Addendum No. 2

CHARTER TOWNSHIP OF SHELBY REQUEST FOR QUALIFICATIONS (RFQ) POLICE STORAGE BUILDING DESIGN/BUILD SERVICES

This ADDENDUM is intended to provide additional information to supplement the Request for Proposals, dated June 13, 2018.

ELECTRICAL SITE POWER PLAN
SCALE: 1" = 20'

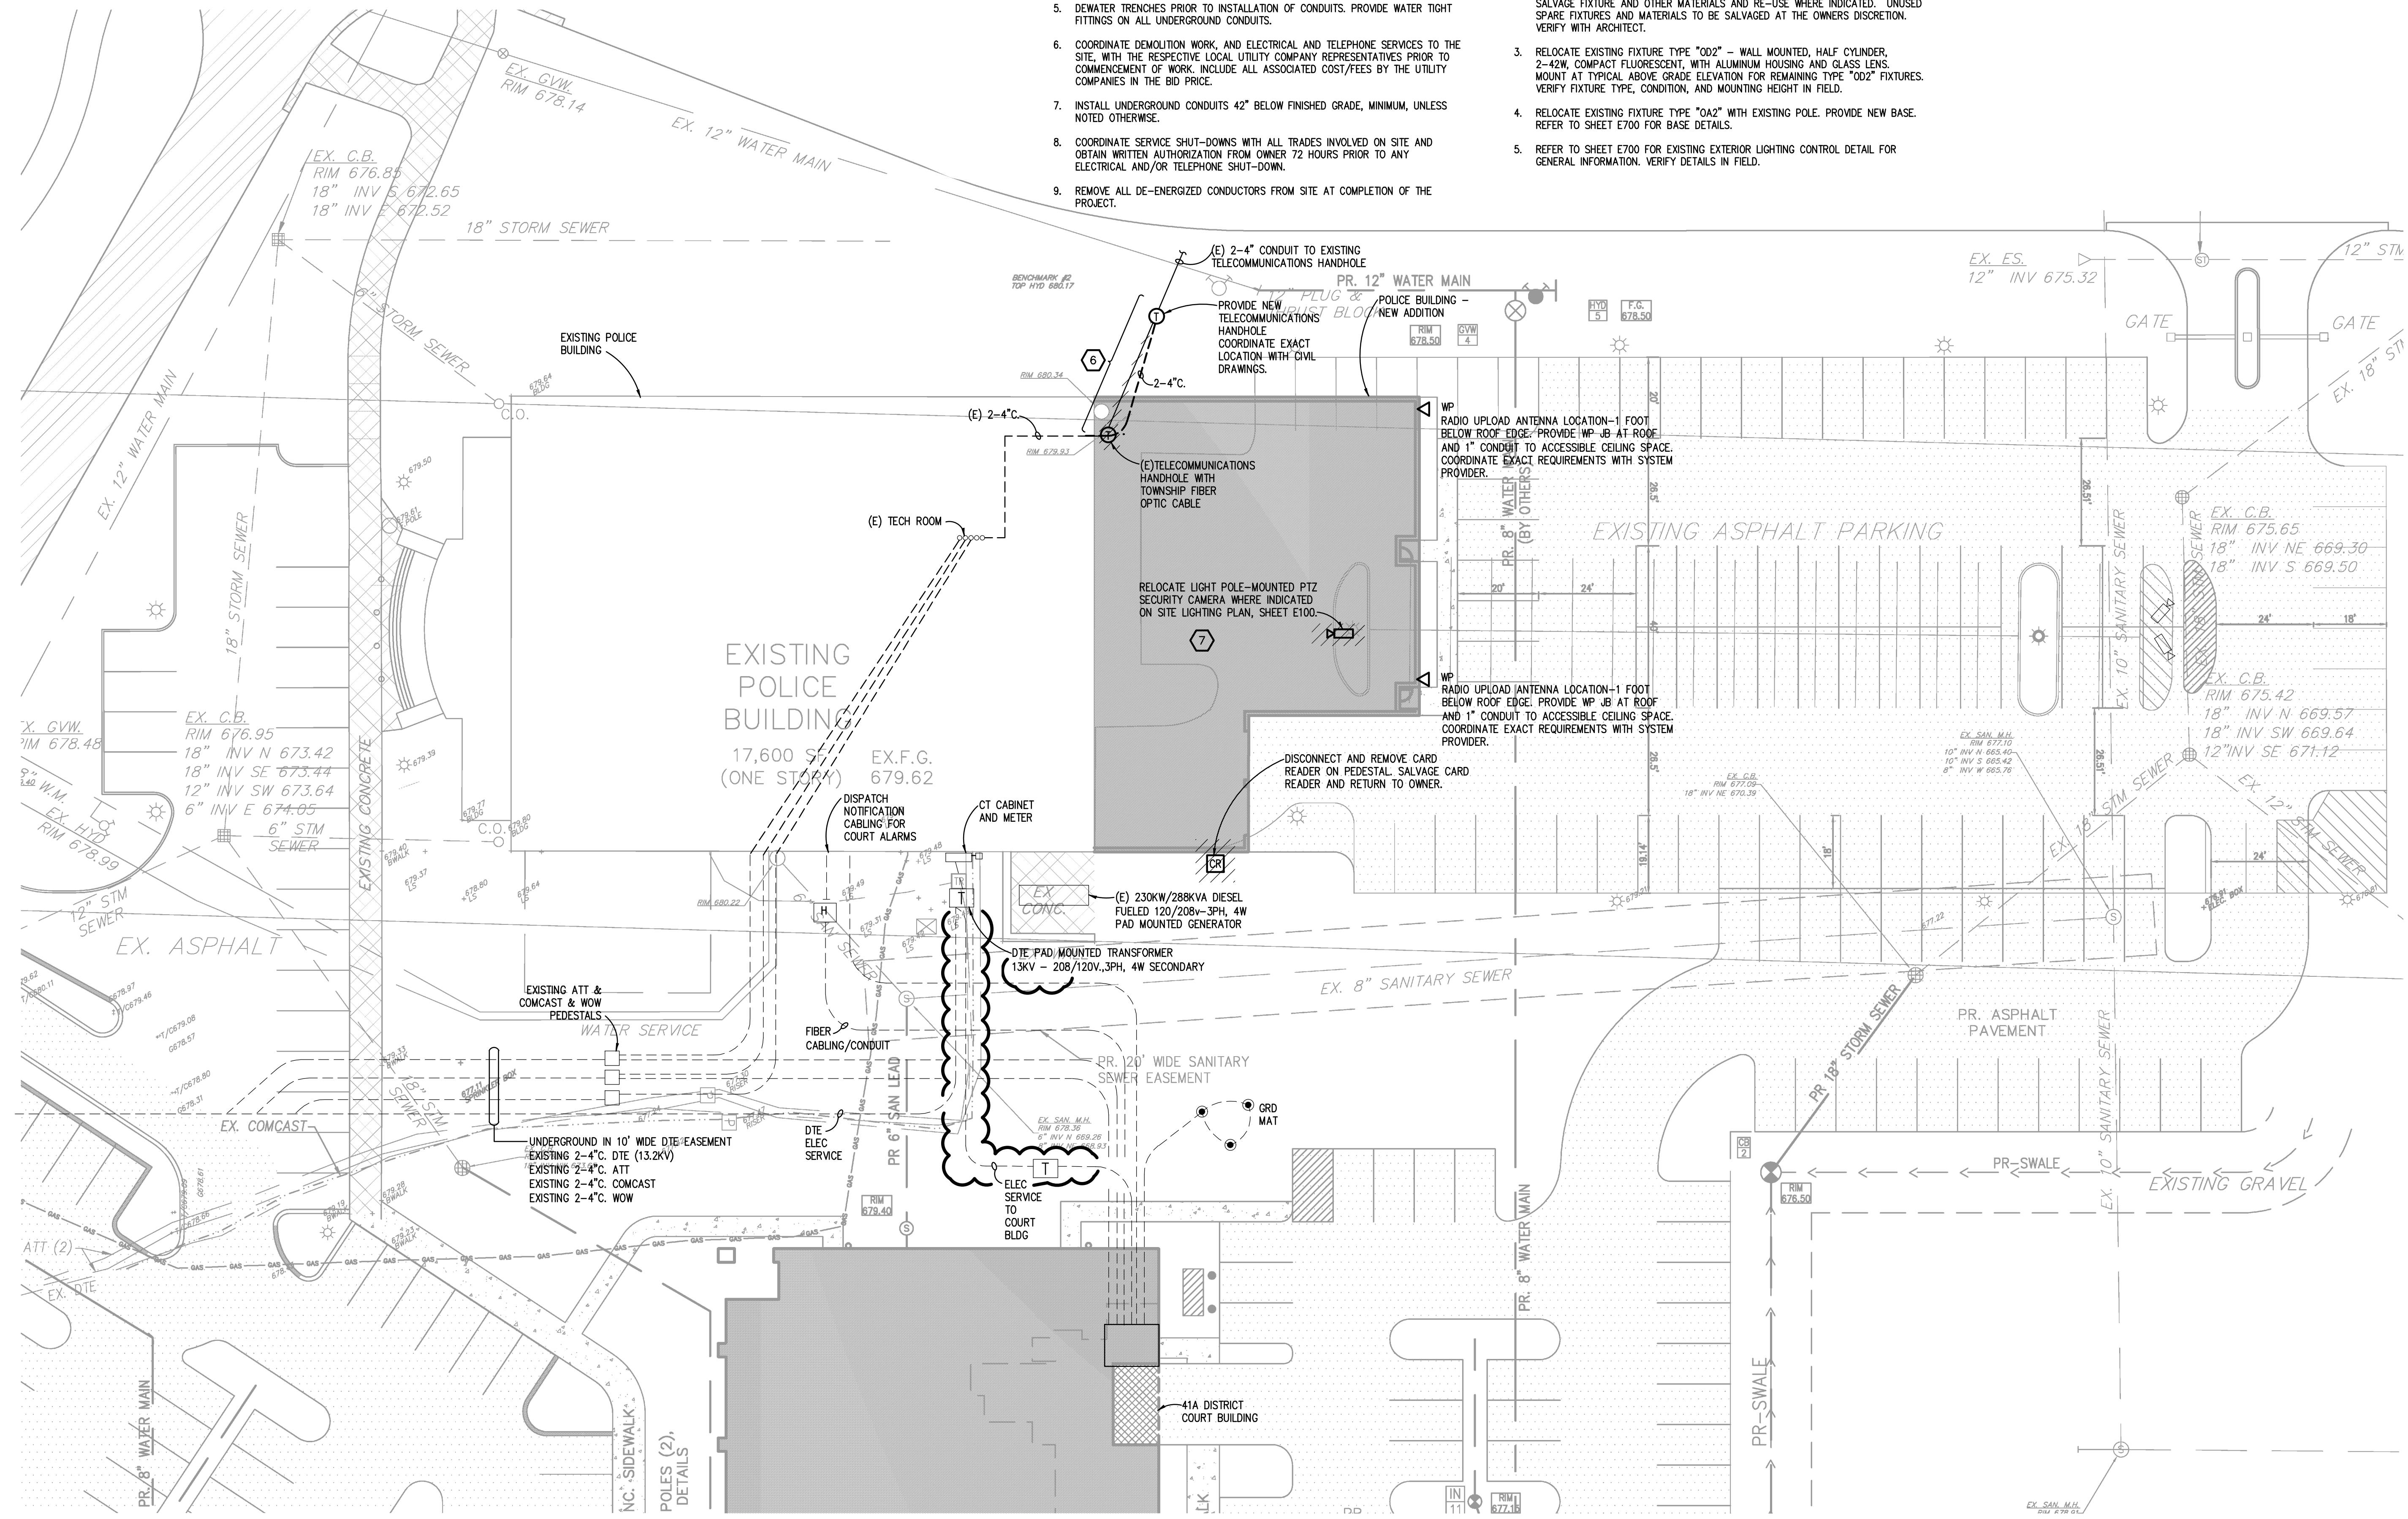
1. *The bid documents still do not indicate the source of the power for the storage building as well as if it is to be run underground or overhead. Please advise.*

3. *New Electric and Gas Service???? -or are we pulling service from existing building????*
 - See above response to Question 1 for electrical information. Contractor shall also be responsible for design and coordination of gas service to proposed building. Available gas information is indicated on the Electrical Site Plan.

- Contractor shall be responsible for design and coordination of power to proposed building. Attached for reference is the most recent Electrical Site Plan.
